CEDAR CREEK SOUTH

AMENDMENT TO CEDAR CREEK SOUTH

MASTER DEVELOPMENT & P.U.D. PLAN

THIS PLAN AMENDS PUD PLAN NO. 02-014 APPROVED BY THE PLANNING COMMISSION ON JANUARY 22, 2003

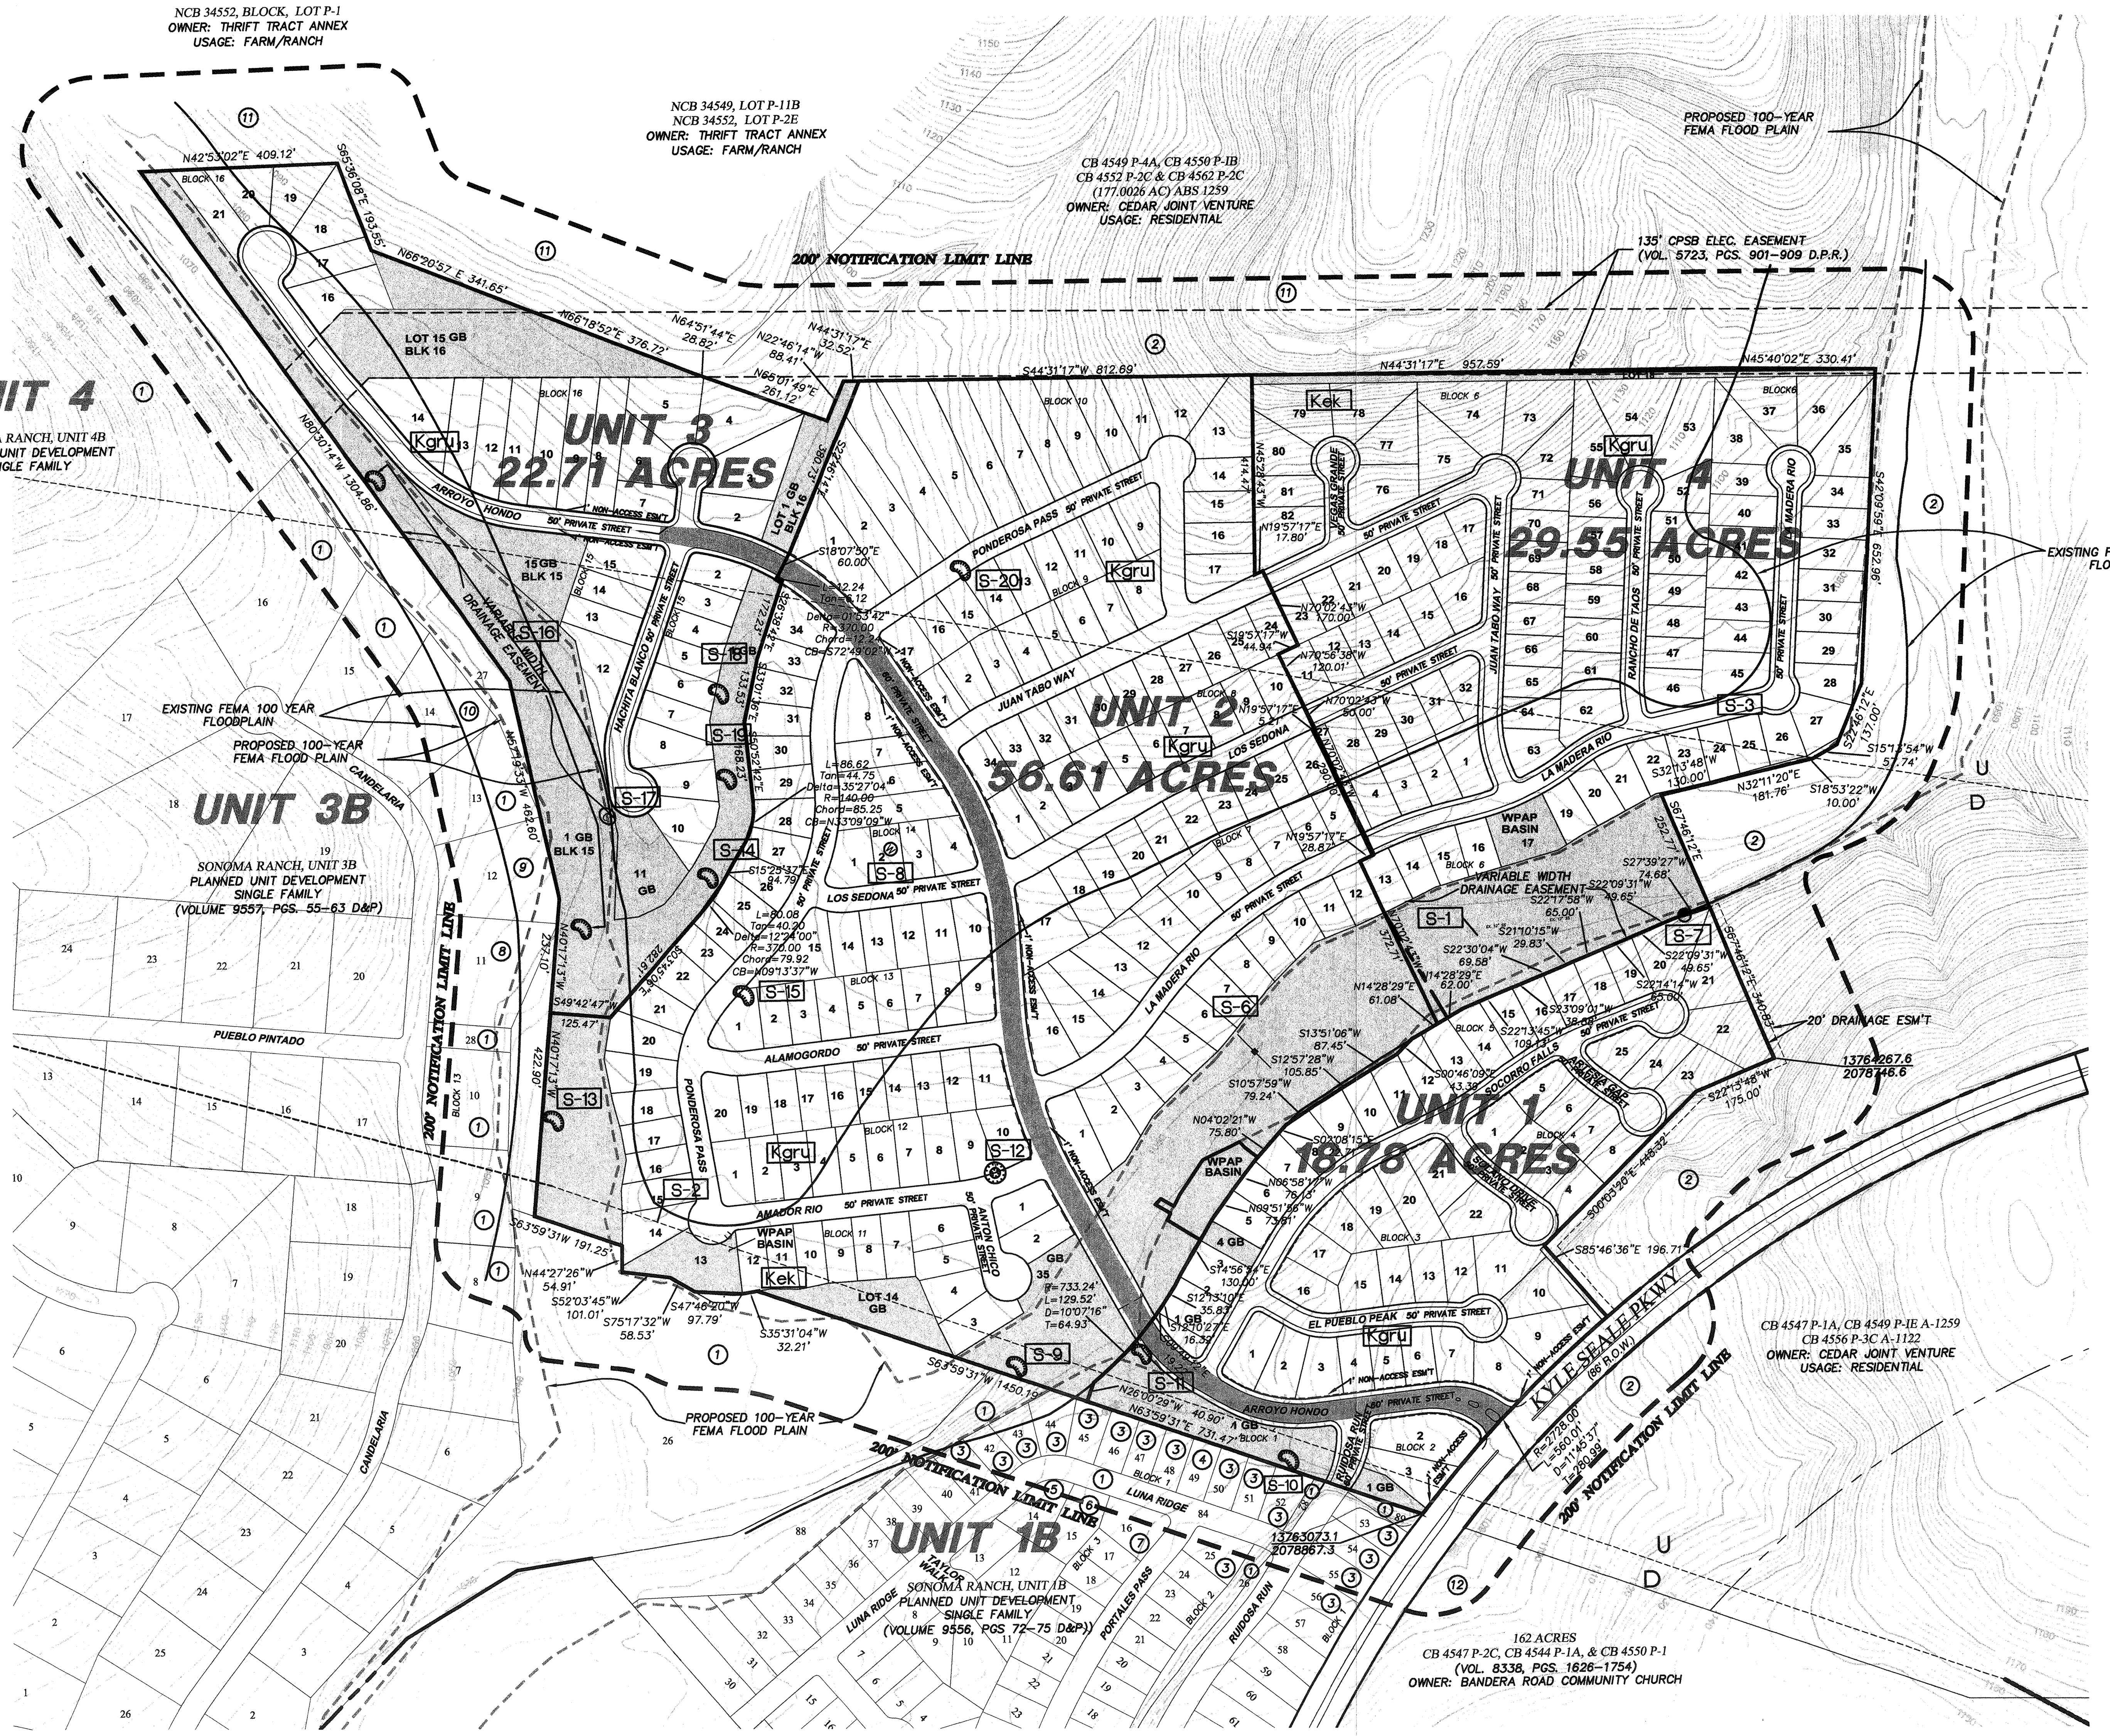
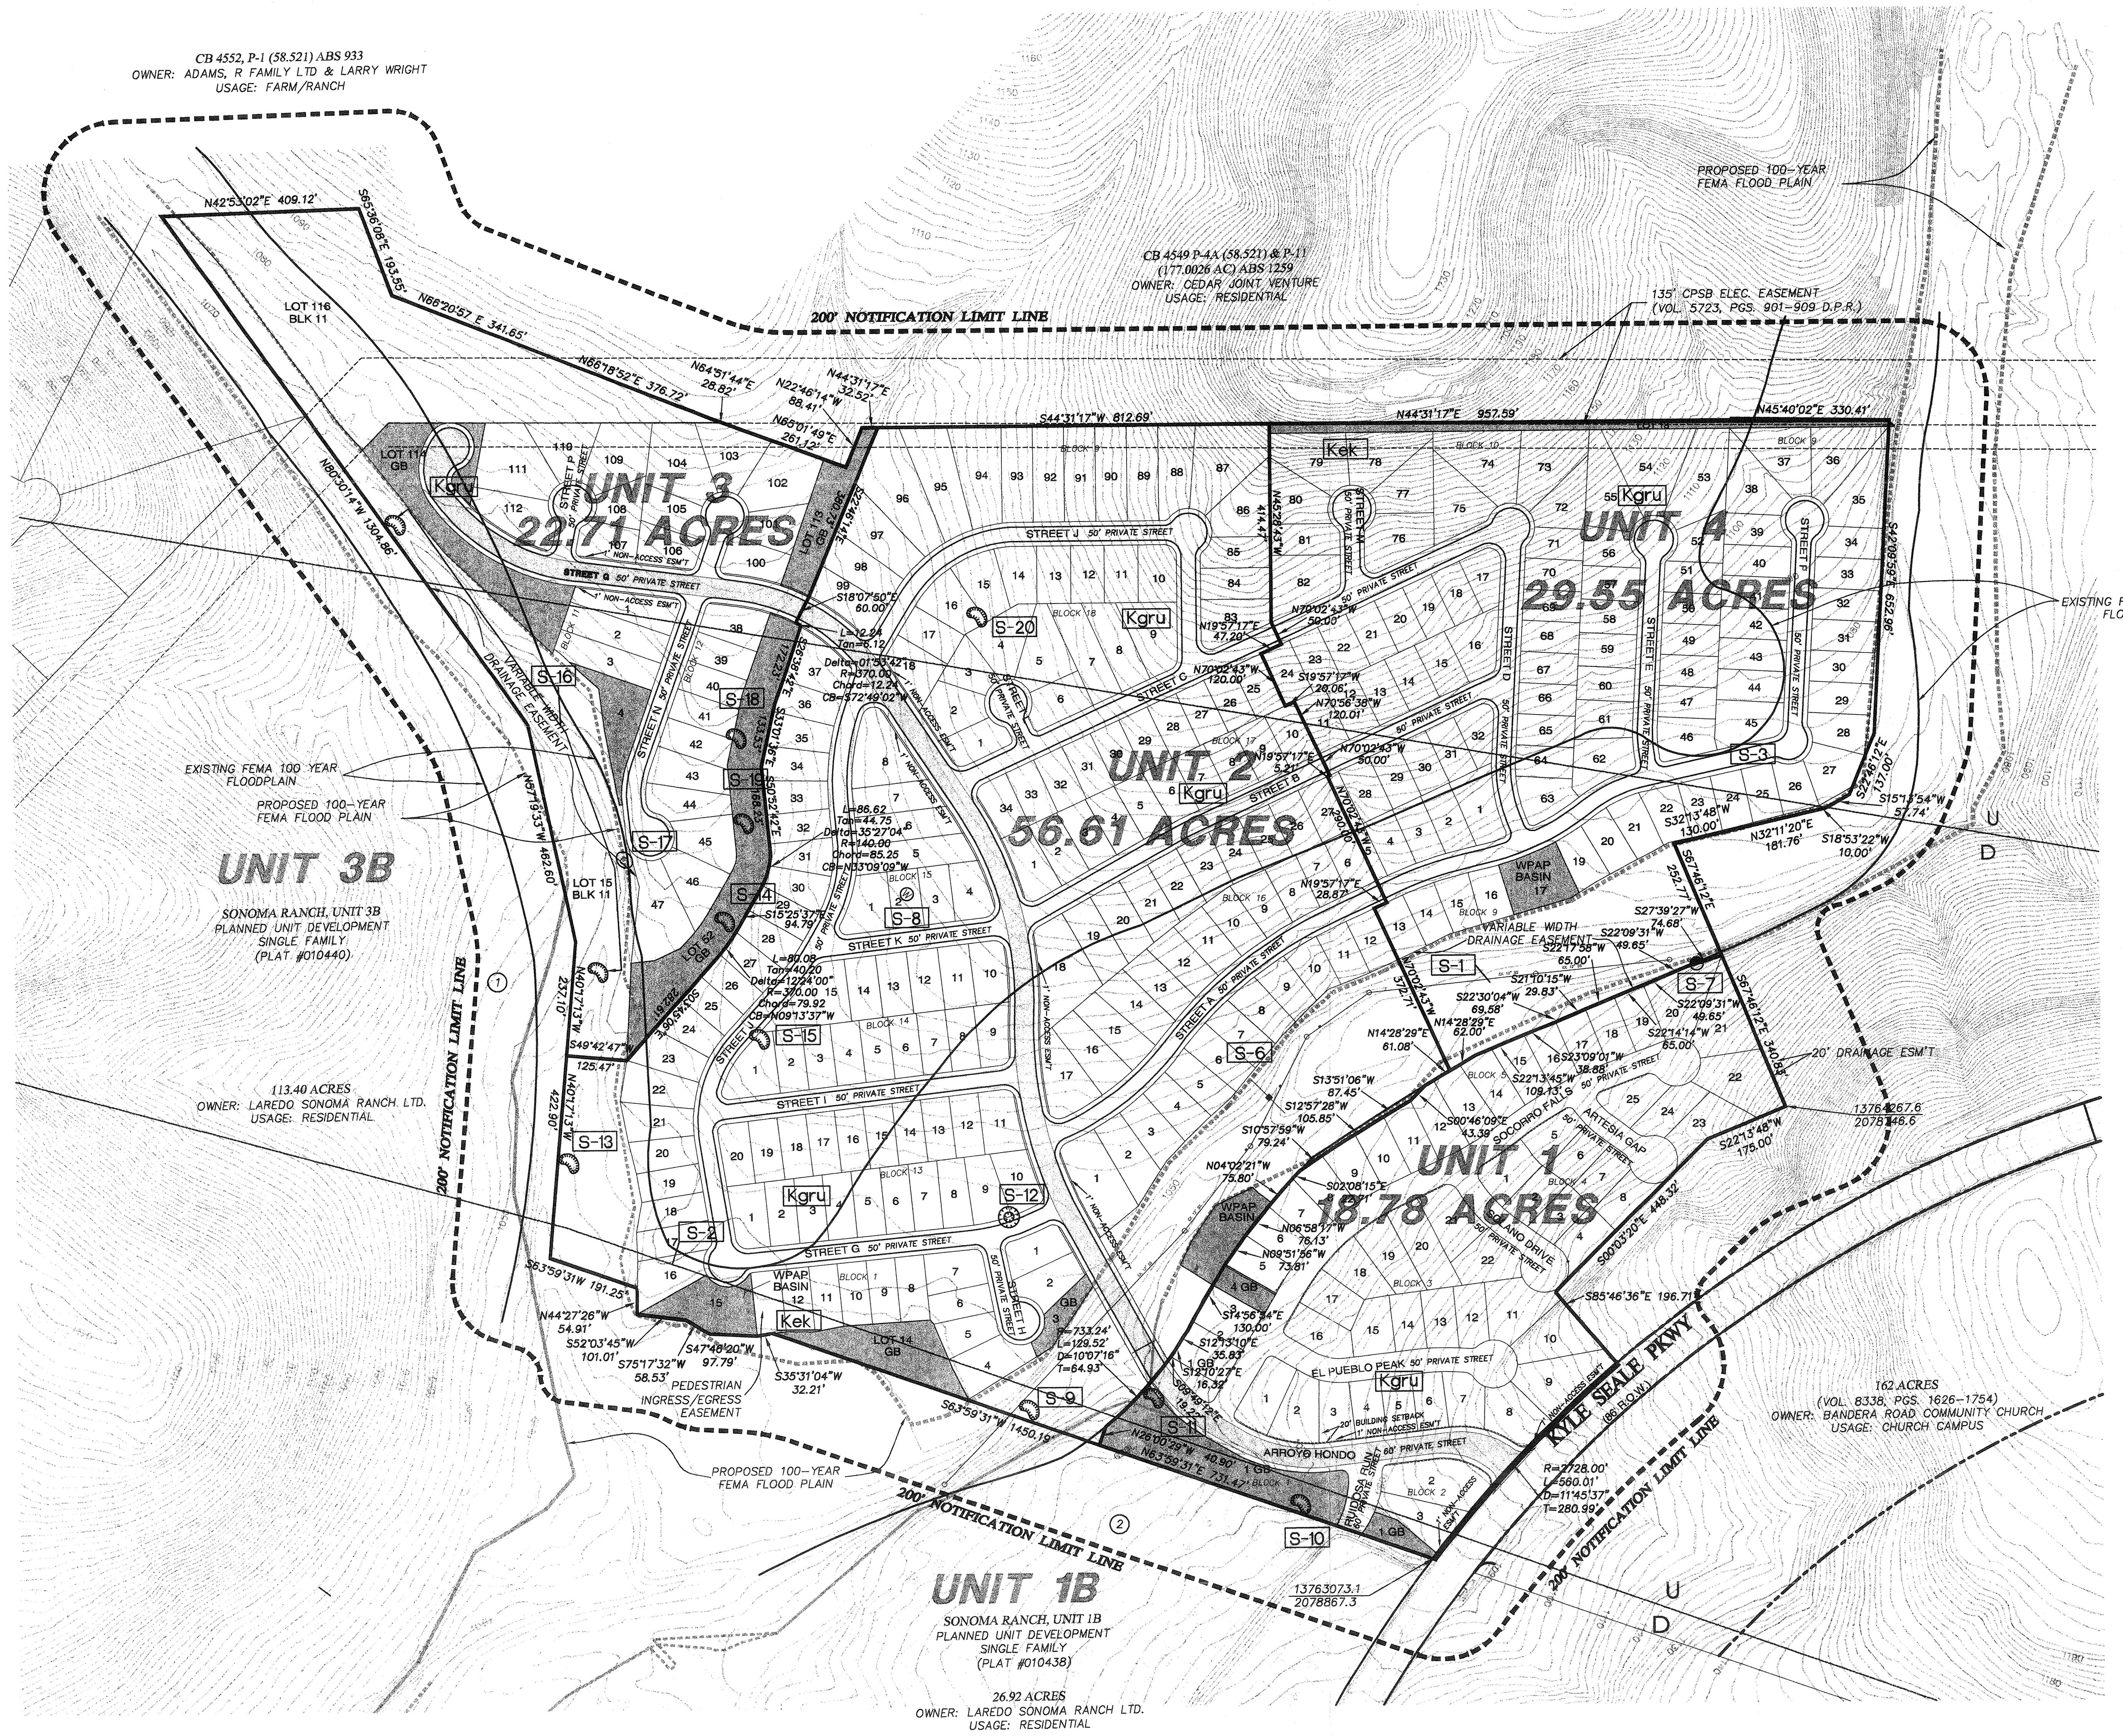
1. DELETED SMALL CUL-DE-SAC STREET "L" LOCATED WITHIN THE INNER BLOCK OF THE EASTERN PORTION OF UNIT-2 NORTH OF STREET "J". DELETED SMALL CUL-DE-SAC STREET "P" LOCATED WITHIN THE WESTERN PORTION OF UNIT-3 NORTH OF STREET "Q."

2. ELIMINATED THE HORIZONTAL CURVATURE AT STREET "J" TO SIMPLIFY THE GEOMETRY OF THE ROAD, TO IMPROVE TRAFFIC CIRCULATION AND EXTENDED STREET "Q" TO PROVIDE A MORE EFFICIENT ARRANGEMENT OF LOT LAYOUT.

3. ADDED ONE LOT TO UNIT II FROM UNIT IV TO HAVE A BETTER LINE DIVISION BETWEEN THE TWO UNITS.
4. OVERLAY THE OPEN SPACE AREA AT LOT 116 THE NORTHWEST SIDE OF THE PROPERTY WITH ADDITIONAL RESIDENTIAL LOTS.

5. CORRECTED SUMMATIONS OF DATA IN THE OPEN AREA CALCULATIONS TABLE THAT WERE ERRONOUS IN THE PREVIOUS PLAN.
6. UPDATED OPEN SPACE RATIO FROM THE CORRECTED DATA.

7. ADDED APPROVED STREET NAMES AND ADJUSTED LOT AND BLOCK NUMBERS BASED ON NEW LOT LAYOUT.
8. CORRECTED THE SHADING ON 60' LOCAL TYPE "B" PRIVATE STREET AND GREENBELTS.

9. UPDATED ADJACENT PROERTY OWNER INFORMATION.
